# ADDENDUM NO. 1

## 2015 - Installation of 3 Precast Concrete Bridges

Essex County, NY

May 28, 2015

**NORTH FOOTING DETAIL**  
 3/4"=1'-0"

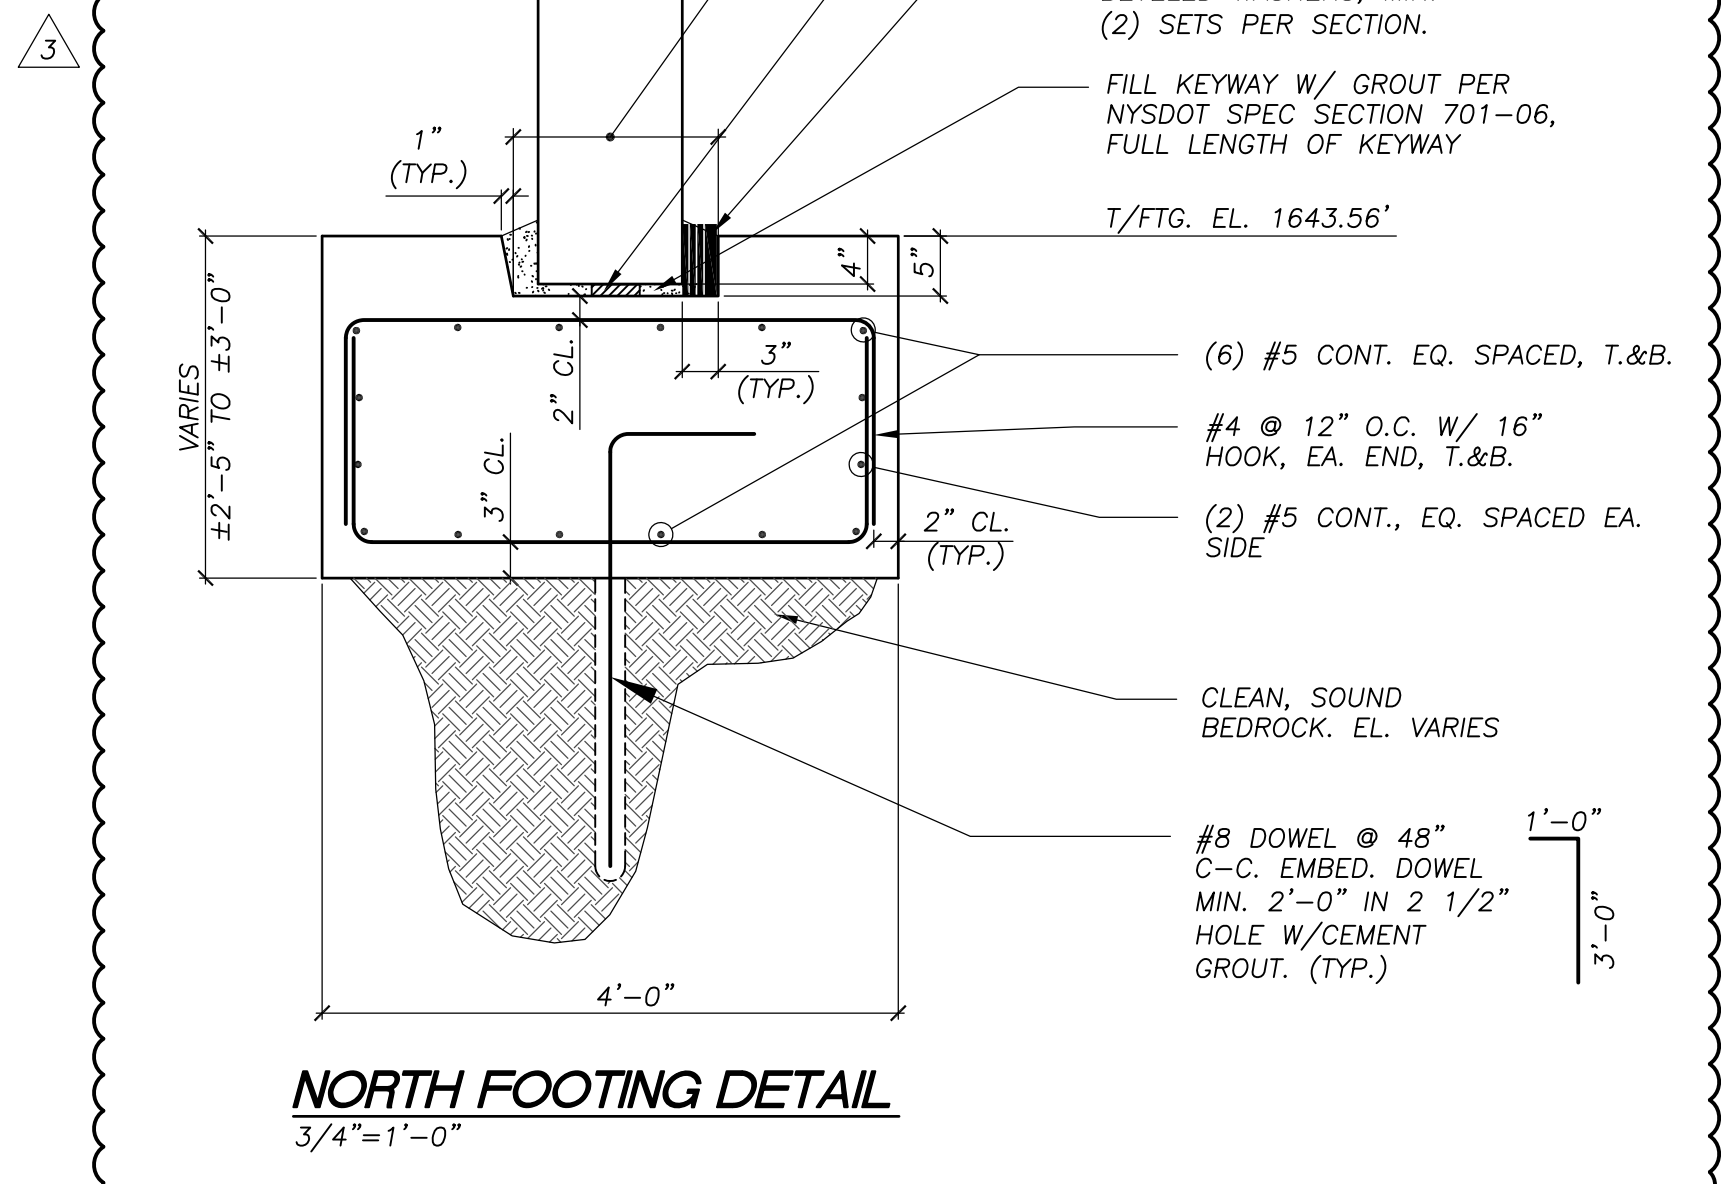
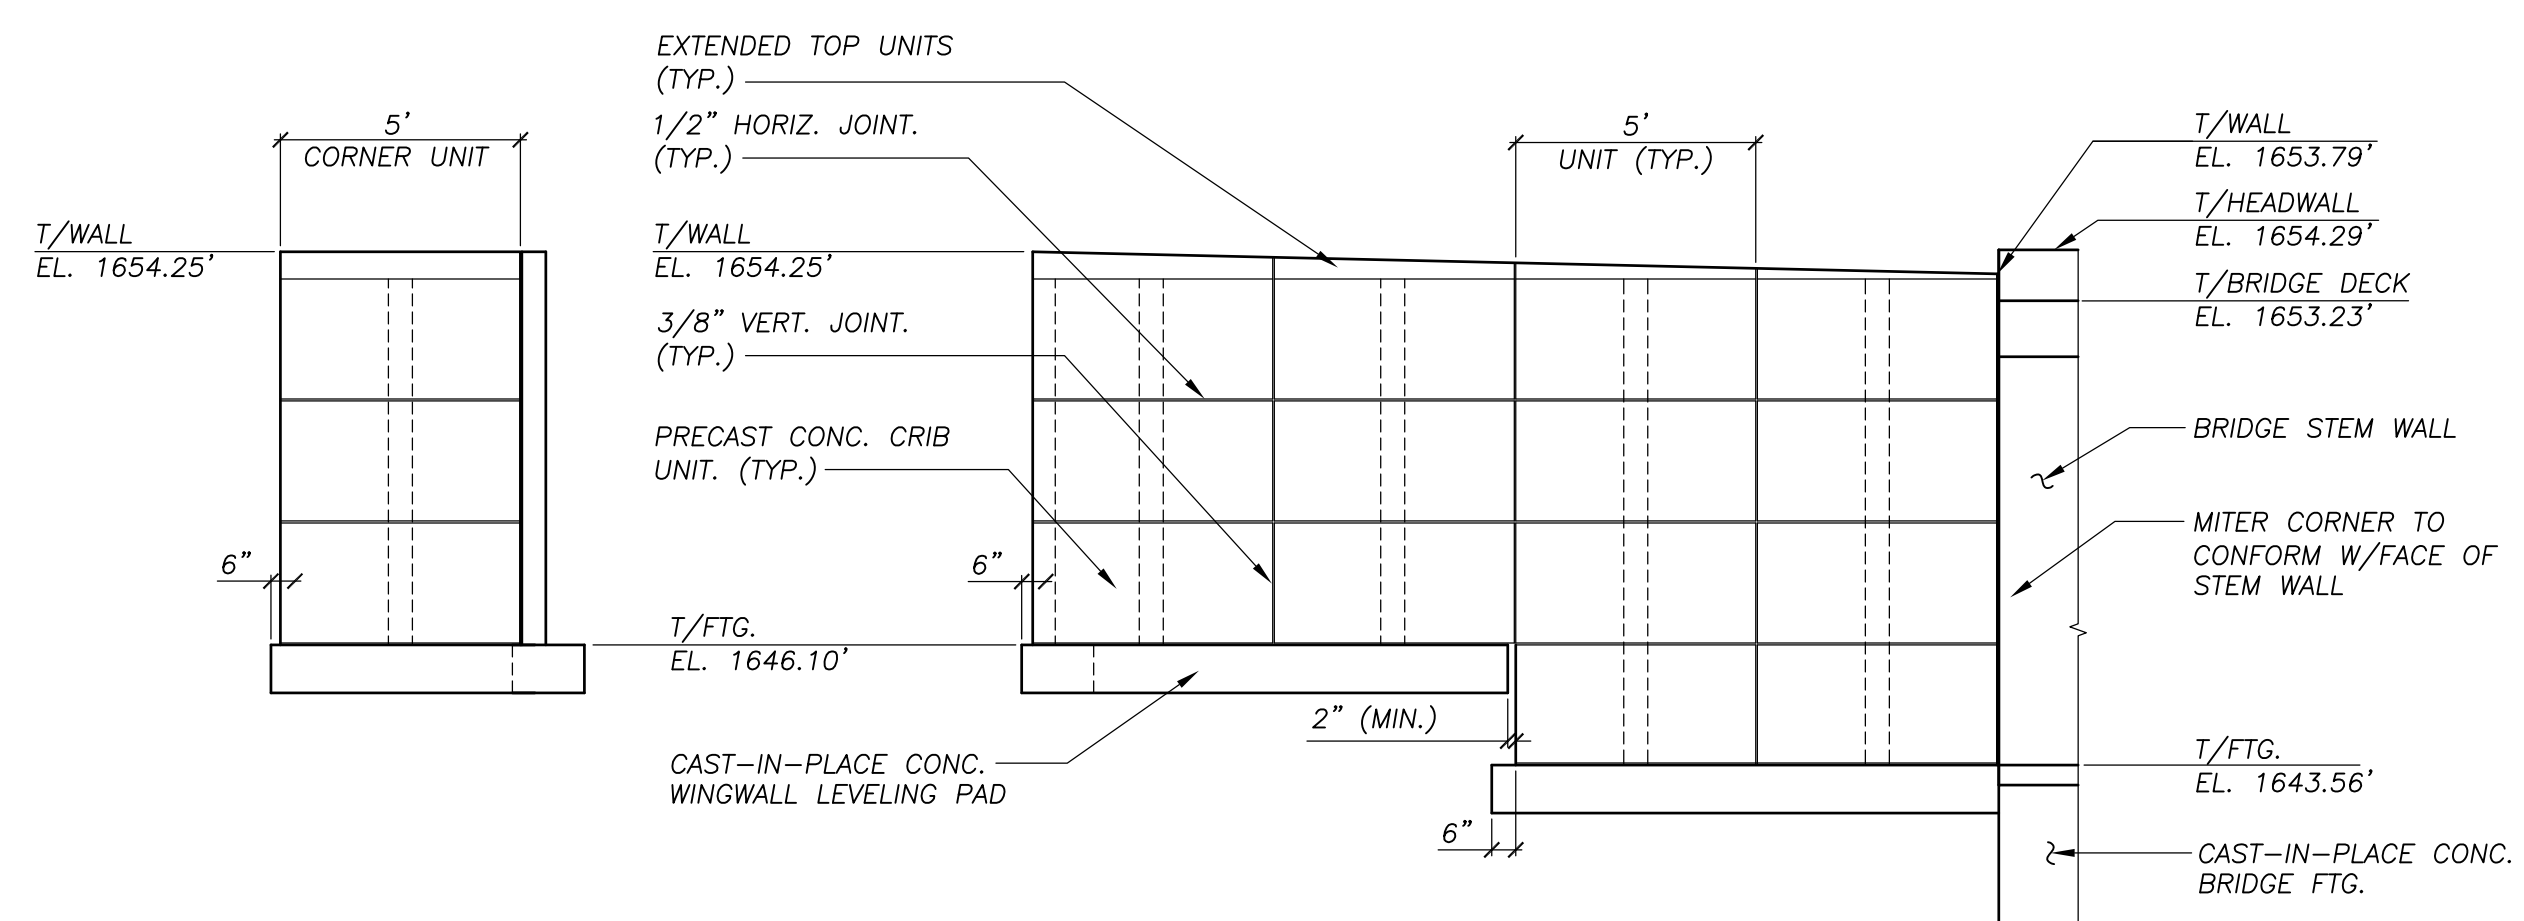
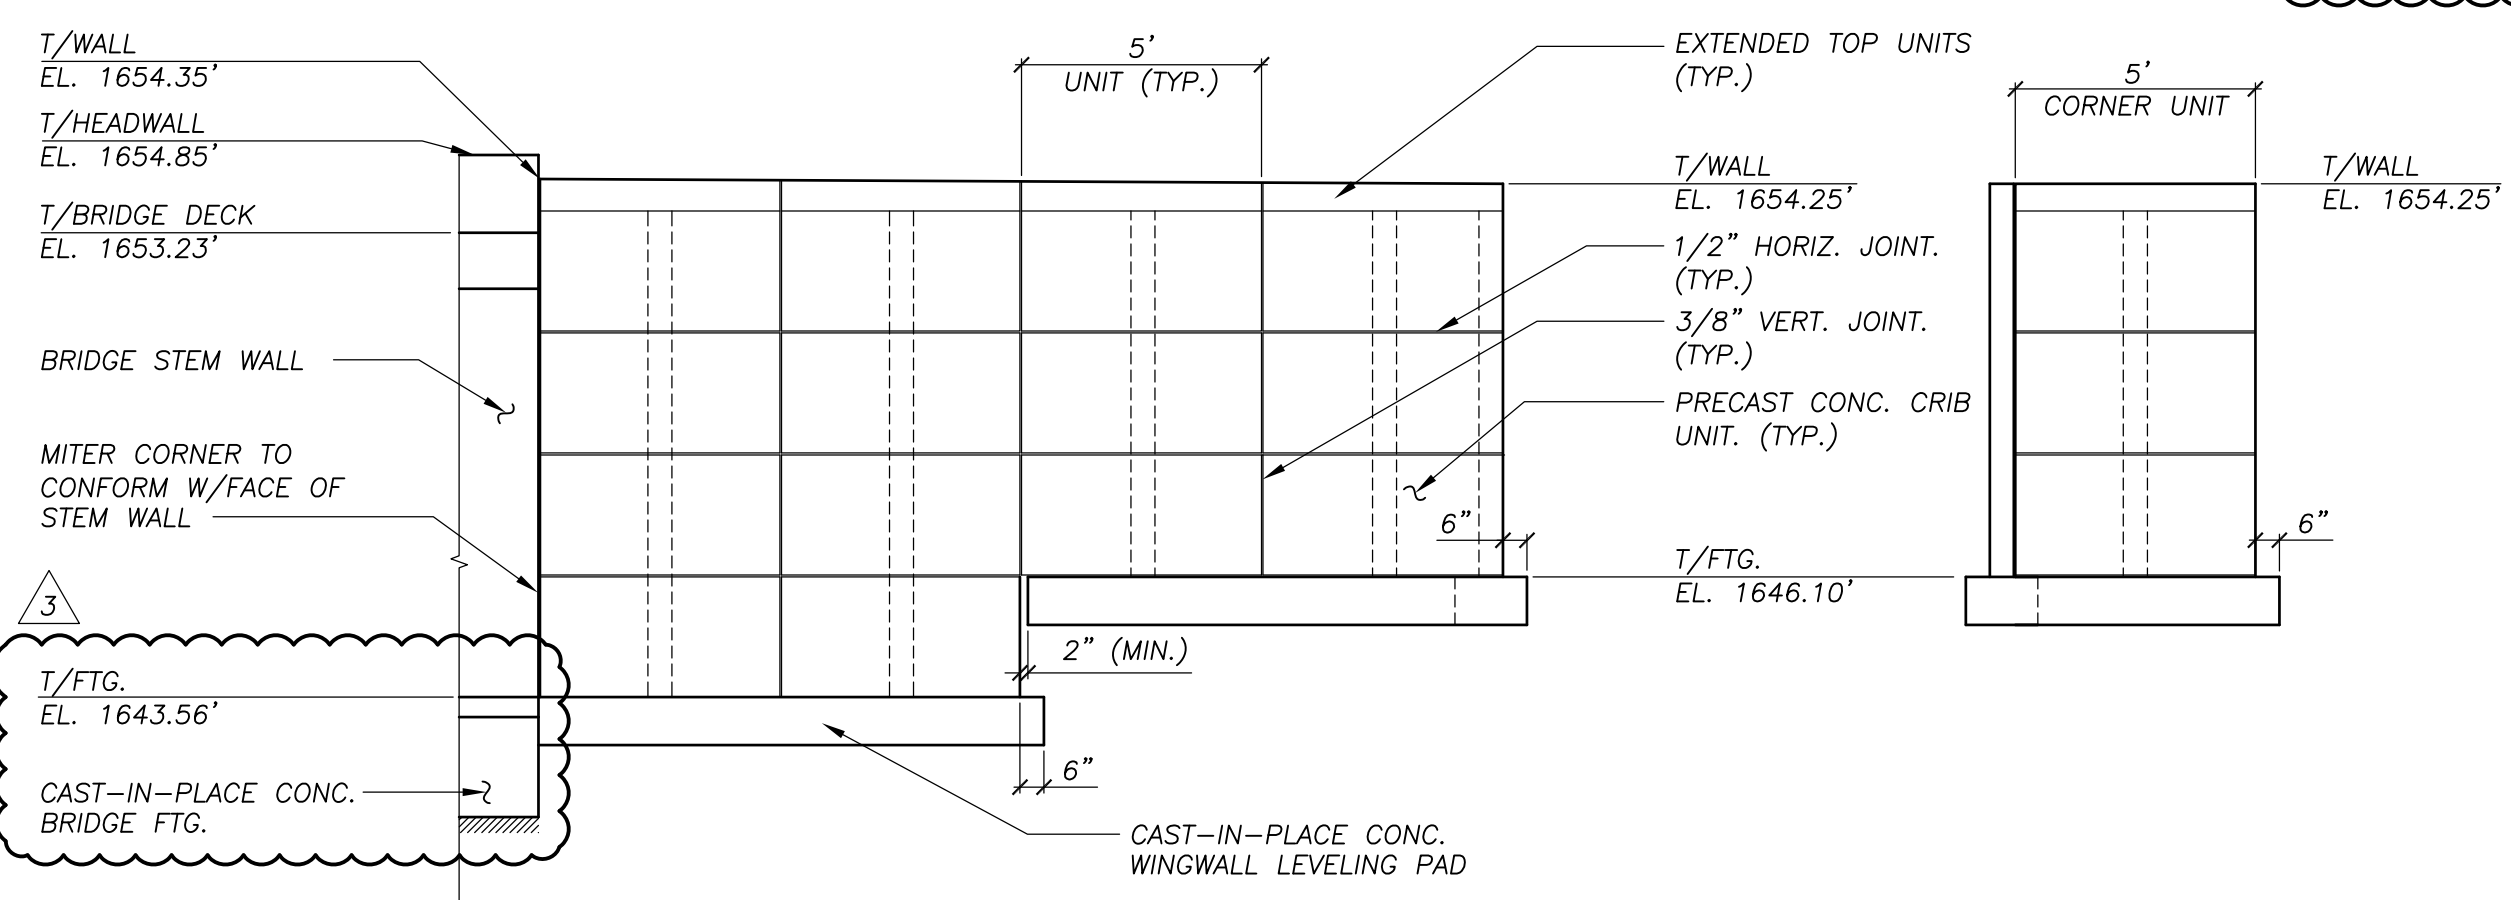
REVISIONS		
REV.	DATE	DESCRIPTION
0	1/19/15	ISSUED FOR REVIEW
1	2/9/15	MODS. PER TNC REVIEW
2	4/27/15	BID AND CONSTRUCTION
3	5/27/15	MODS. TO NORTH FOOTING
